CITY OF SAN ANTONIO

PROJECT: SEELING CHANNEL IMPROVEMENTS - PHASE I

ADDENDUM NO. 4

DATE: August 29, 2012

PROJECT NO.:	60184822	DATE:	JULY 2012
DRWN. BY:	M.G.	DSGN. BY:	SDB
CHKD. BY:	SDB	SHEET NO.	173

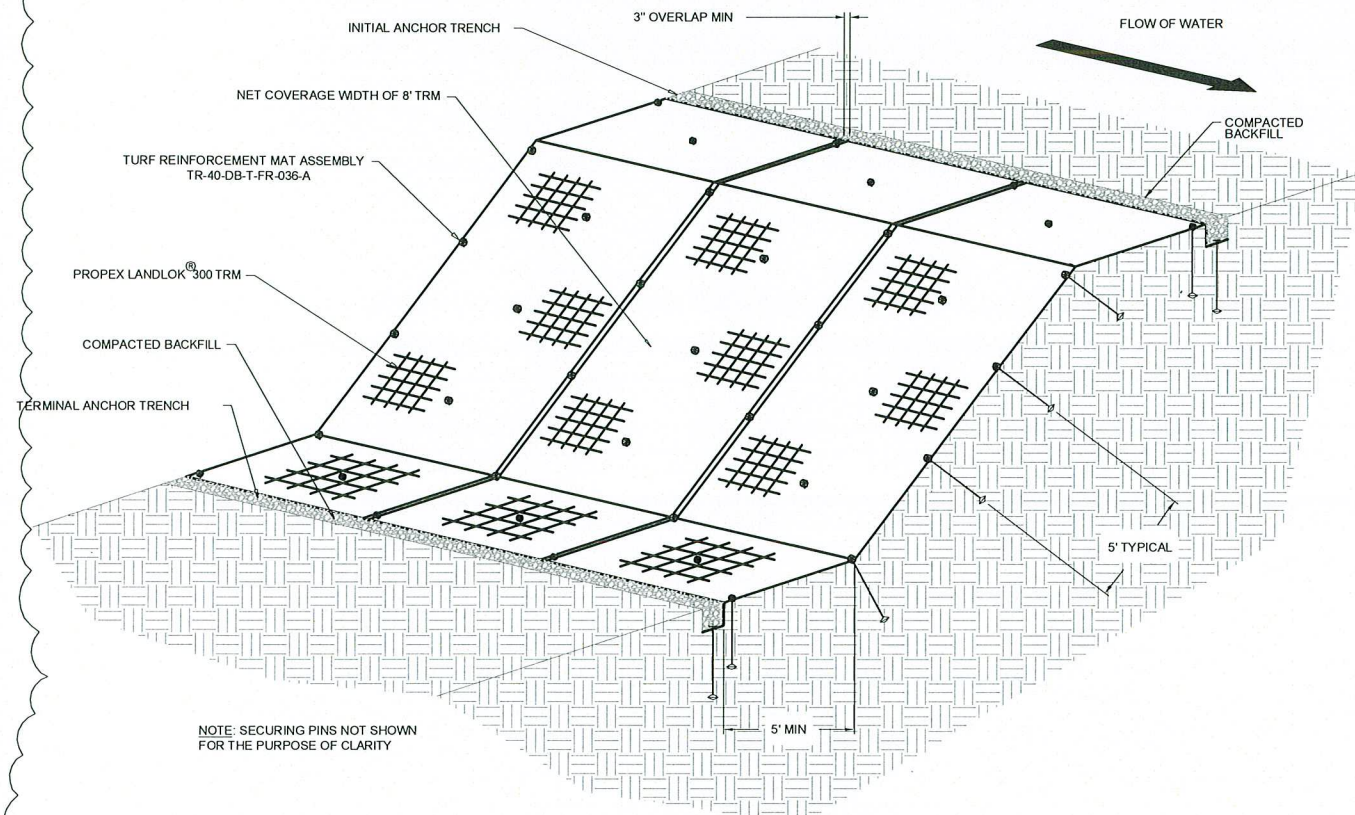
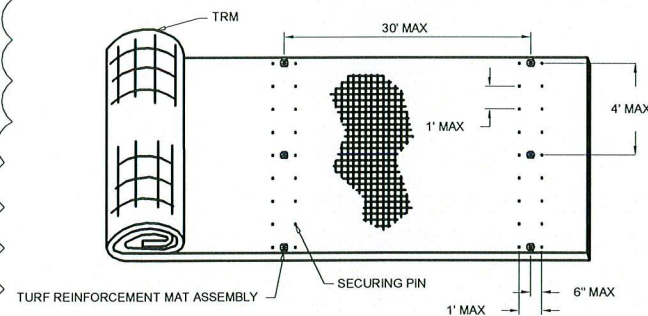
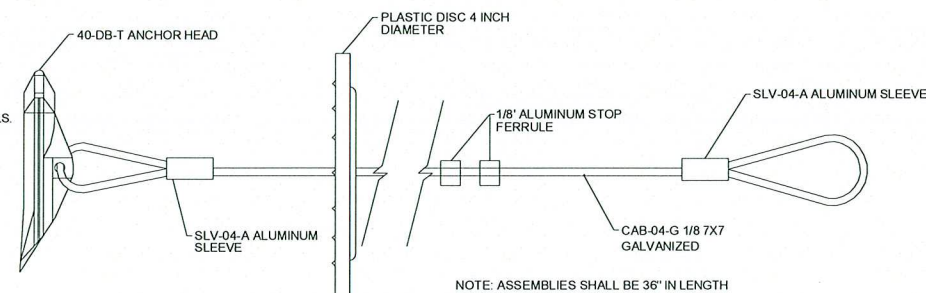
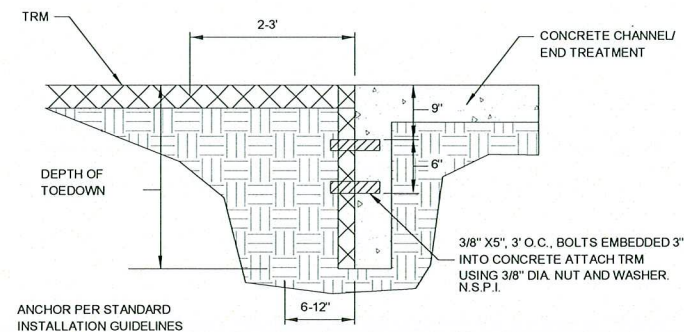
- a. Remove plan sheet 173 and replace with the revised sheet attached to this addendum.
10. S. Josephine-Tobin Dr Bridge
- a. Remove the following plan sheets and replace with the revised and attached sheets:

PROJECT NO.:	60184822	DATE:	JULY 2012
DRWN. BY:	DSM	DSGN. BY:	JVS
CHKD. BY:	BE	SHEET NO. 246 OF	481

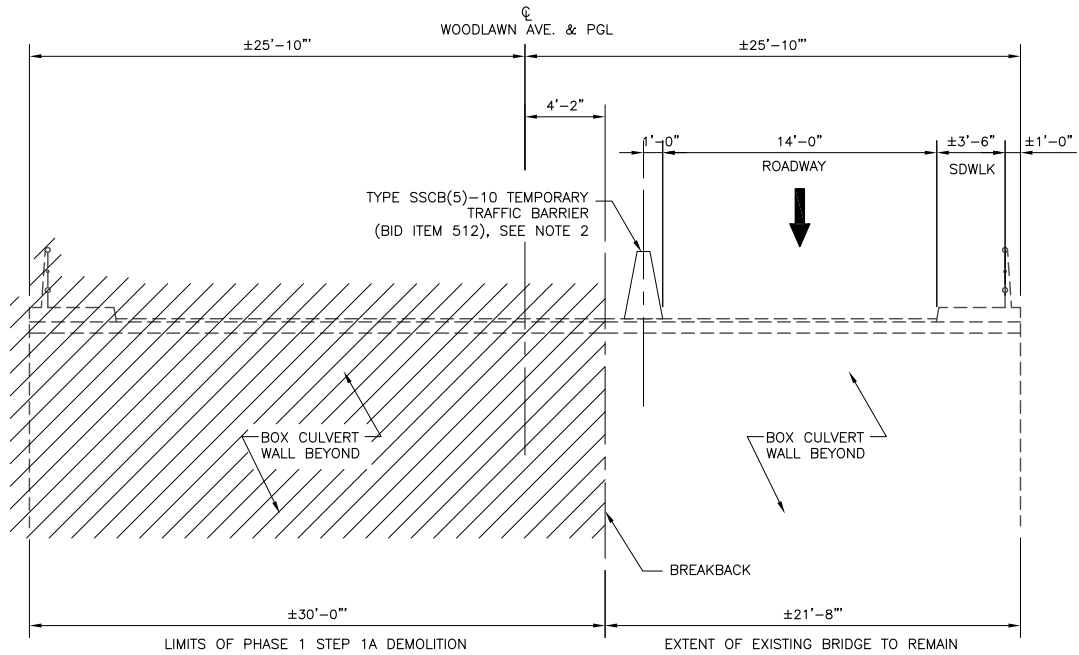
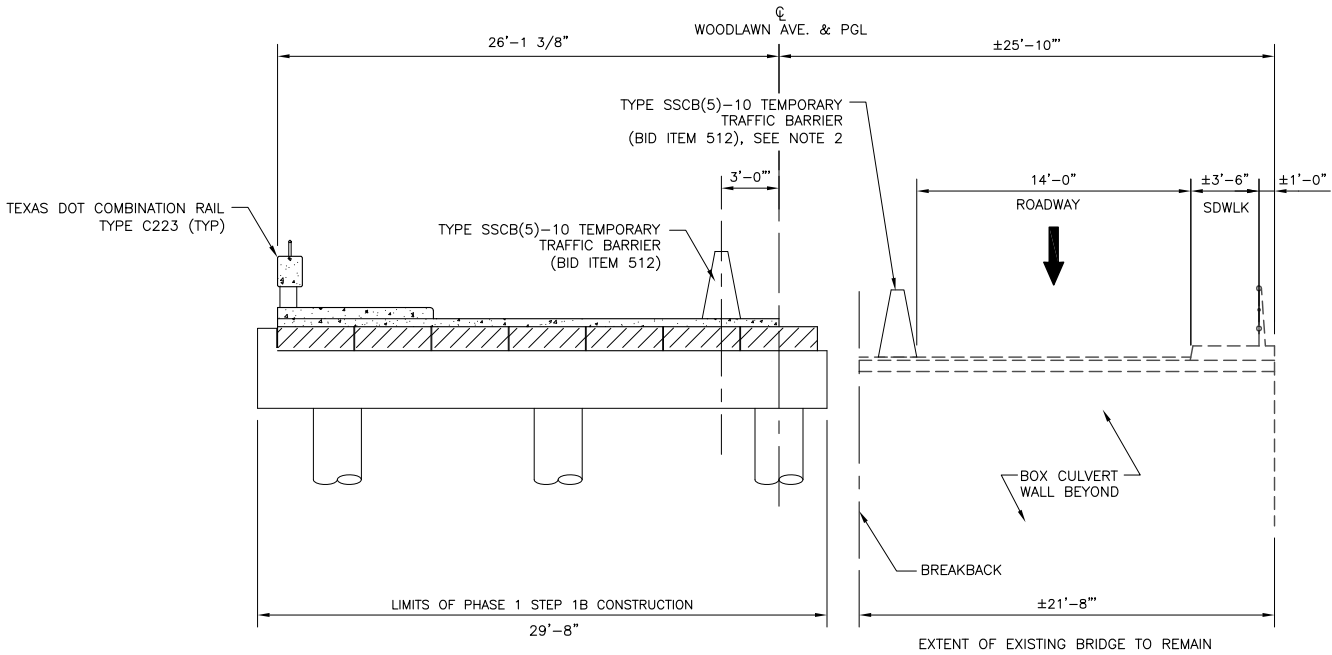
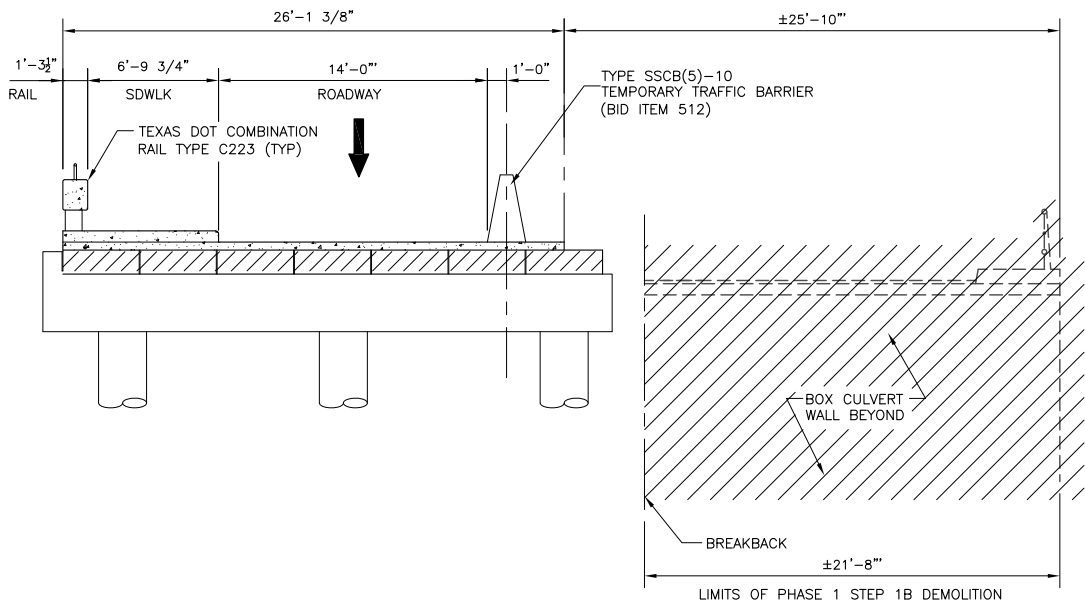
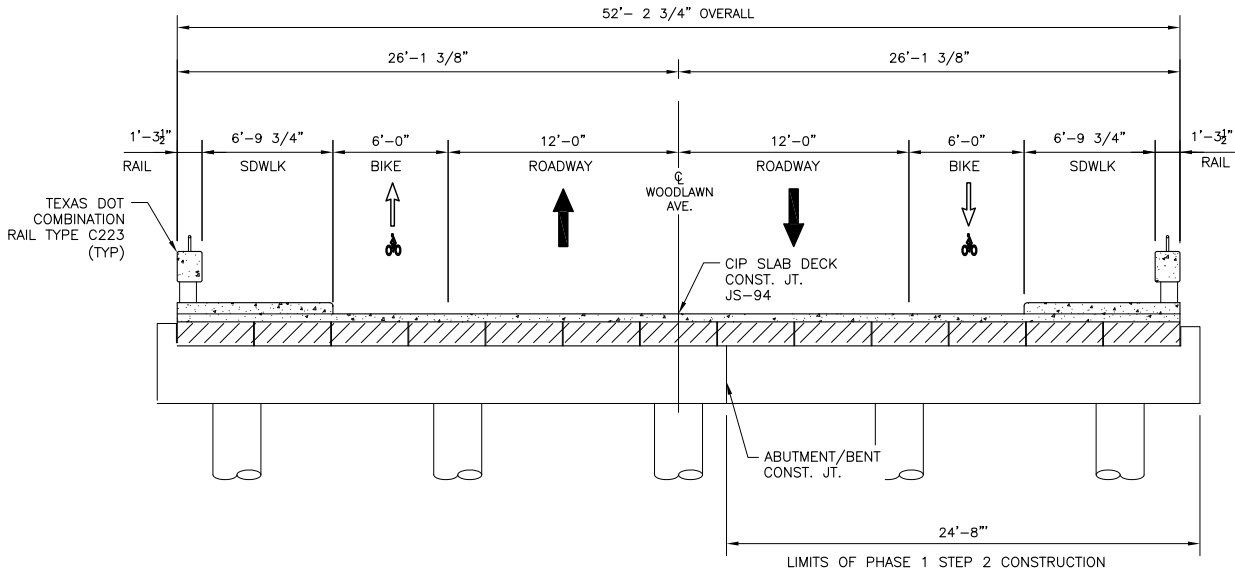
- Q25. *On the Schedule, page 2, activity 230 – the north side of Woodlawn Bridge is being built first. Elsewhere it looks like the south side of the bridge is planned to be built first. Please clarify.*
A25. The north side of the W. Woodlawn Ave. Bridge will be constructed first in accordance with the Traffic Control Plans. Sheet 246 is updated with this Addendum 4.

PROJECT NO.: 60184822	DATE: JULY 2012
DRWN. BY: DSM	DSGN. BY: JVS
CHKD. BY: BE	SHEET NO. 250 OF 481

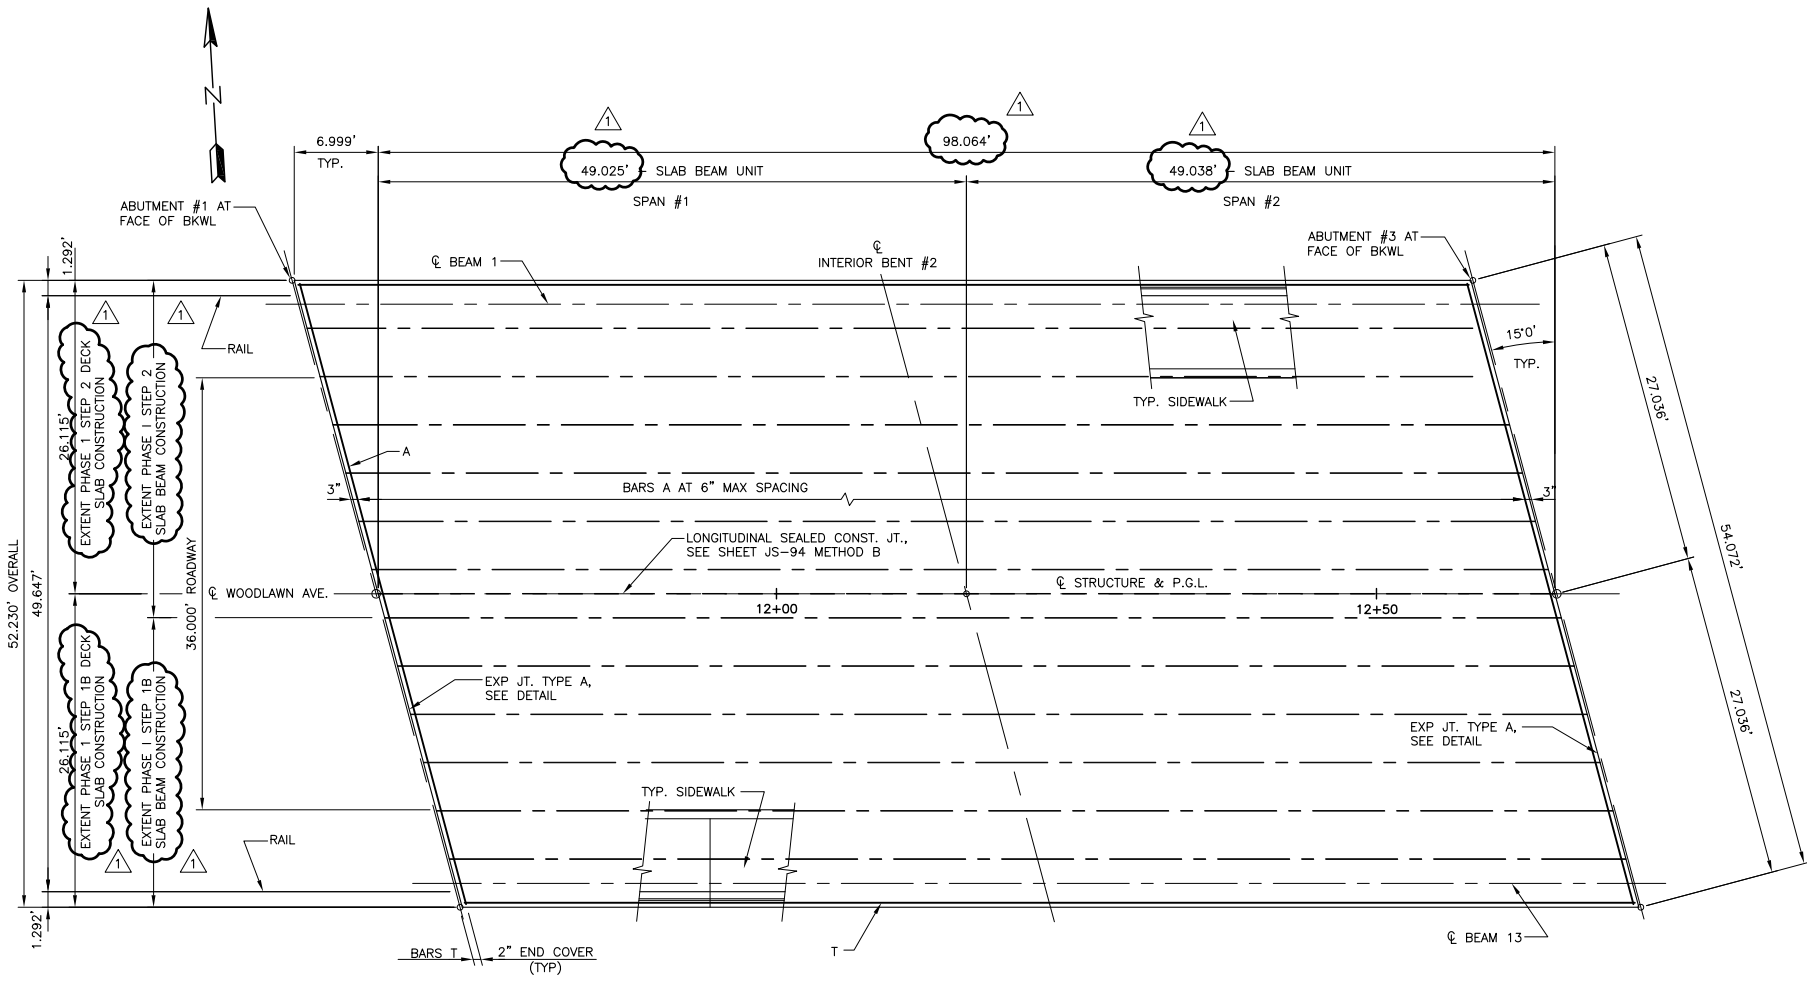
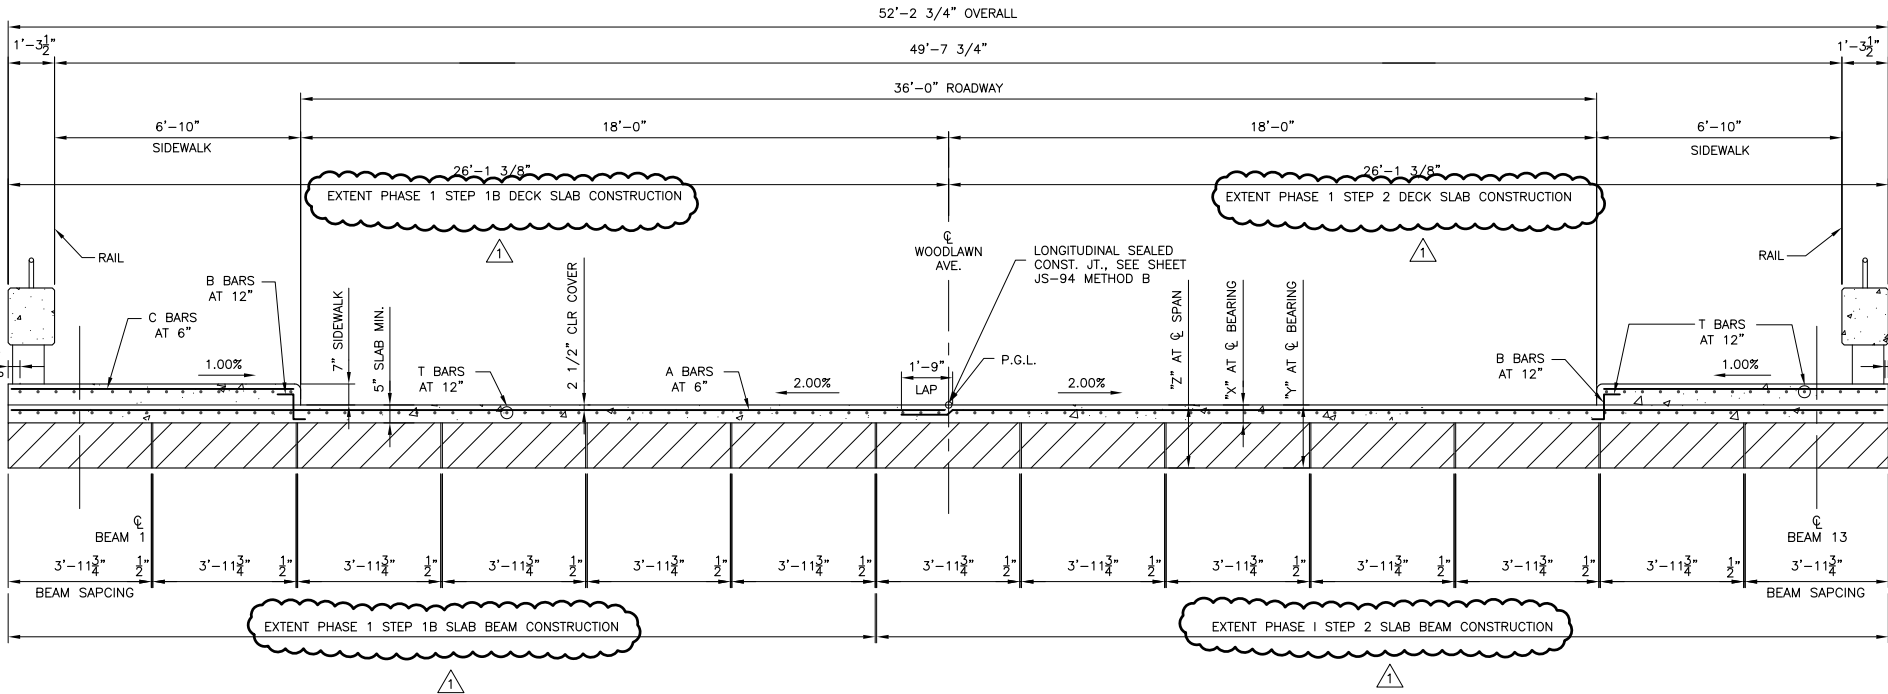
- Q16. *Slab quantities on all three bridges appear to be wrong. Can you verify?*
A16. Slab quantities have been updated with this Addendum 4.
- Q17. *Bridge Sidewalk quantities on all bridges appear to be wrong. Can you verify?*
A17. Bridge Sidewalk quantities have been updated with this Addendum 4.
